TECHNICAL NOTE

Project Title: Land to the East of Ffordd Amazon, Crymlyn Burrows, Neath Port Talbot (Planning Application Reference: P2025/0124)

Report Reference: 794-PLN-TRP-00294-04c V2

Post Application Response NPTCBC's Active Travel Team

Figure 1: Shared Cycleway Width

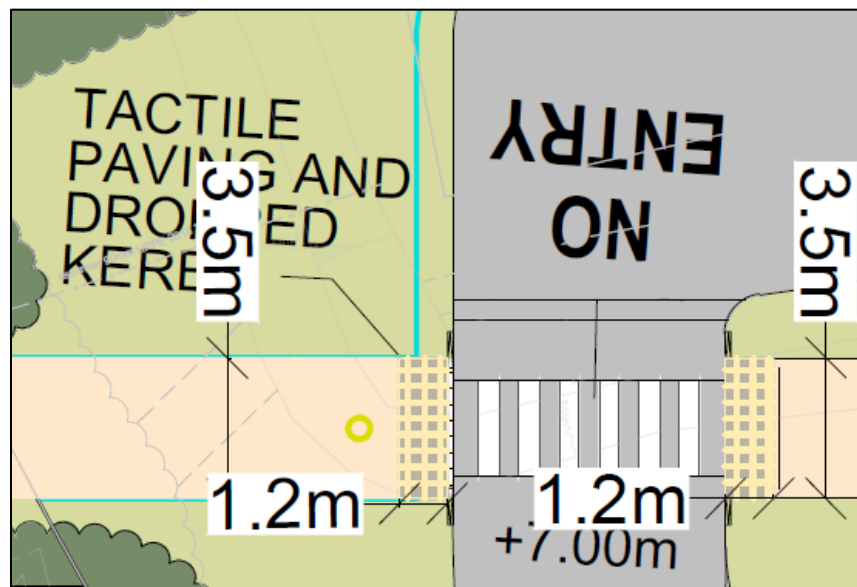
- 1.15 Paths need to be wide enough in order to meet ATAG standards.

- 1.16 ATAG Standards suggest for shared cycle and pedestrian paths **“width should reflect the level and type of use forecast with a minimum of 3.0m width on primary cycle routes, or 2.5m on less busy secondary routes”**. The route in question is classed as a less busy secondary route.

- 1.17 DE401 Shared pedestrian and cycle track, alongside road of the ATAG suggests ***“Unsegregated cycle tracks should include additional width where they are bounded by vertical features. Additional width required is:***
- ***Kerb up to 150mm high: add 200mm;***
 - ***Vertical feature 150-600mm high: add 250mm;***
 - ***Vertical feature above 600mm high: add 500mm.”***
- 1.18 The shared cycleway has fencing along both sides, which is more than 600mm high. On that basis, the 3m shared cycleway detailed below has been increased to 3.5m, which allows for the additional 500mm suggested in ATAG.
- 1.19 This is shown on **Figure 1** below and on the Site Layout Plan at **Annex 2**.

Figure 2: Shared Cycleway Bollard

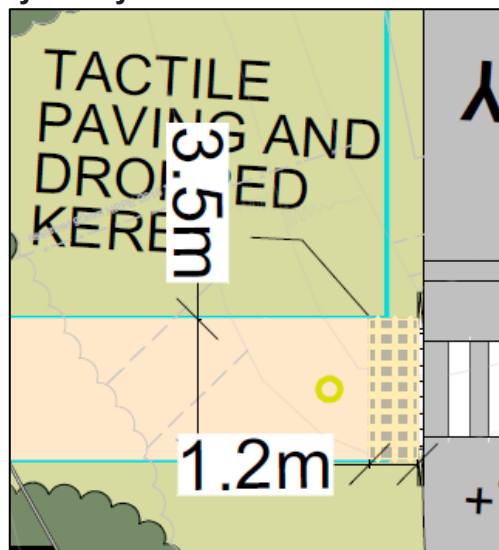
- 1.20 Please confirm what the two black features on the path circled are. Please refer to ATAG (ref 15.3.5 p263). It is recommended that any barriers are replaced with bollards as it will create better permeability through the site.

- 1.21 The black features identified above are barriers to stop, or slow, cyclists at the end of a path for safety reasons.
- 1.22 As per ATAG (ref 15.3.5 p263) these have been amended and now include a single central bollard, as shown on **Figure 2** below and on the Site Layout Plan at **Annex 2**.

Figure 3: Gate Width

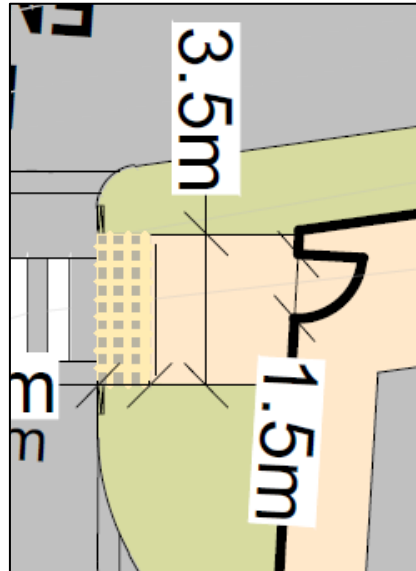
- 1.23 Please confirm the gate width. A minimum of 1.5m is required when open, as per ATAG (ref 9.17.10 p107).

- 1.25 The gate width has been increased to 1.5m and is now in accordance with ATAG standards. This is shown on **Figure 3** below and on the Site Layout Plan at **Annex 2**.

Figure 4: Shared Cycleway Width

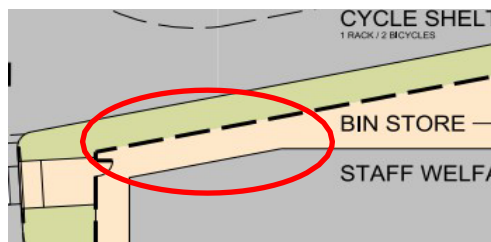
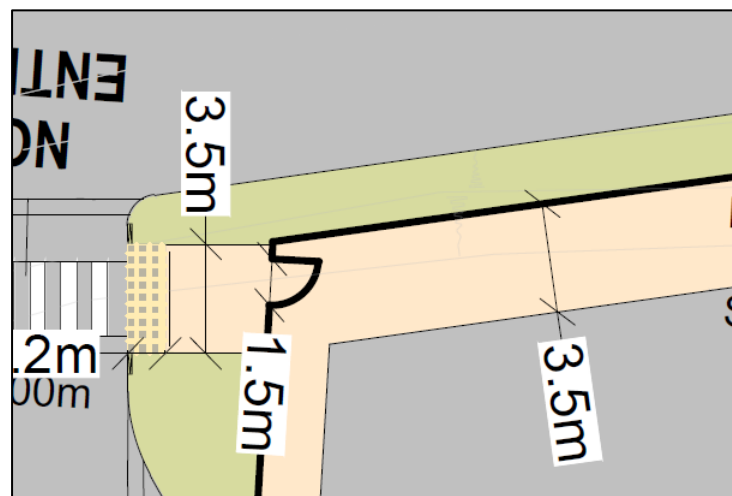
- 1.26 Please confirm the width of the expected shared use path from the gate to the cycle storage meets ATAG standards (as highlighted below).
- 1.27 Paths need to be wide enough to allow shared use to meet ATAG standards (DE401 p380).
- 1.28 The black dashed line appears to be a fence. DE401 states, vertical features above 600mm high require an additional 500mm to the path width.

- 1.29 There also appears to be a lighting column in the narrow section, this would further restrict access. Can this be relocated please.

- 1.30 The shared cycleway has fencing along its northern boundary, which is more than 600mm high. On that basis, this shared surface has been increased to 3.5m, which allows for the additional 500mm suggested in ATAG.
- 1.31 This is shown on **Figure 4** below and on the Site Layout Plan at **Annex 2**.
- 1.32 A Lighting Strategy was submitted as part of the planning application. This has been included within **Annex 3** for reference. It is however anticipated that a detailed Lighting Strategy will be required by Condition.

Figure 5: Tactile Paving Dimensions

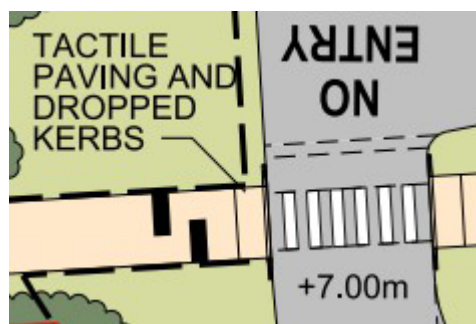
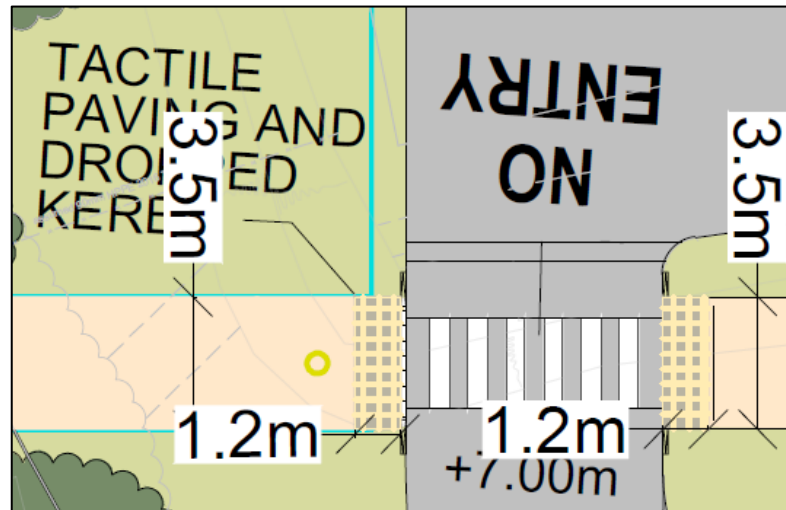
- 1.33 Please confirm the tactile dimensions and ensure they meet standards as per the *Guidance of the Use of Tactile Paving Surfaces*:
<https://assets.publishing.service.gov.uk/media/61df0c91e90e07037794fe90/guidance-on-the-use-of-tactile-paving-surfaces.pdf>

- 1.34 The dimensions of the tactile paving (3.5m x 1.2m) are shown on **Figure 5** below. The dimensions meet standards as per the *Guidance of the Use of Tactile Paving Surfaces*.

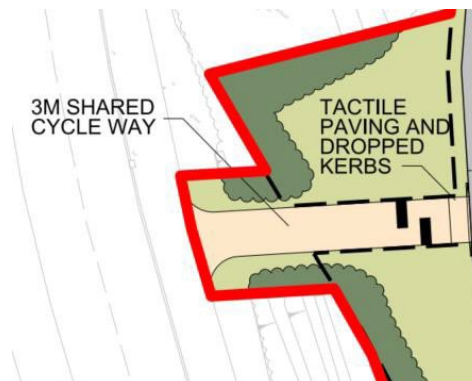
- 1.35 The black dashed line appears to be a fence. DE403 states, vertical features above 600mm high require an additional 500mm to the path width. This could potentially add 1m to the width of the path. Please confirm this feature meets ATAG requirements.

- 1.36 The shared cycleway has fencing along both sides, which is more than 600mm high. On that basis, the 3m shared cycleway detailed below has been increased to 3.5m, which allows for the additional 500mm suggested in ATAG.
- 1.37 This is shown on **Figure 5** above and on the Site Layout Plan at **Annex 2**.

Figure 6: Cycle Parking

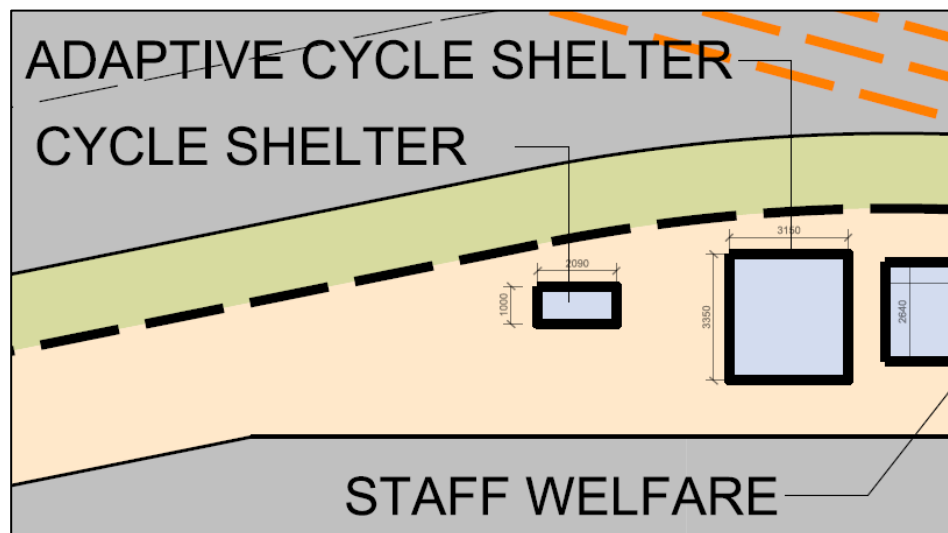
- 1.40 The cycle storage appears to show a total width of 1.09m with a central Sheffield derived stand. This would not meet ATAG standards as per Figure 14.25 below.
- 1.41 Please note the requirement for adaptive cycles parking for disabled people. 1 space minimum. 10% (up to 50 spaces).

- 1.42 The cycle parking on site has been amended and now shows a separate adaptive cycle parking shelter for two adaptive cycles. The shelter is 3.3m long by 1.9m wide to accommodate the Cycle Design Vehicle, with 1.2m additional level transfer/dismount width. This is in accordance with standards suggested in <https://wheelsforwellbeing.org.uk/guide-to-inclusive-cycle-parking>, and is shown on **Figure 6** below and on the Site Layout Plan at **Annex 2**.

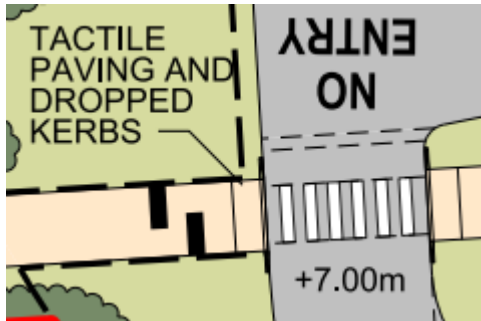
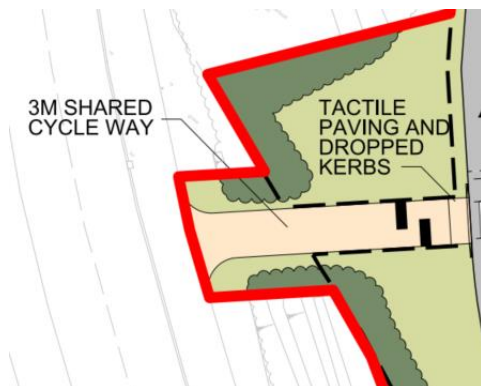
4 Widths	
4.	Paths need to be wide enough in order to meet ATAG standards.
4.1	Please confirm what the two black features on the path circled are. Please refer to ATAG (ref 15.3.5 p263). It is recommended that any barriers are replaced with bollards as it will create better permeability through the site.

4.2	Please confirm the gate width. A minimum of 1.5m is required when open, as per ATAG (ref 9.17.10 p107). 
4.3	Please confirm the width of the expected shared use path from the gate to the cycle storage meets ATAG standards (as highlighted below). Paths need to be wide enough to allow shared use to meet ATAG standards (DE401 p380). The black dashed line appears to be a fence. DE401 states, vertical features above 600mm high require an additional 500mm to the path width.  There also appears to be a lighting column in the narrow section, this would further restrict access. Can this be relocated please.
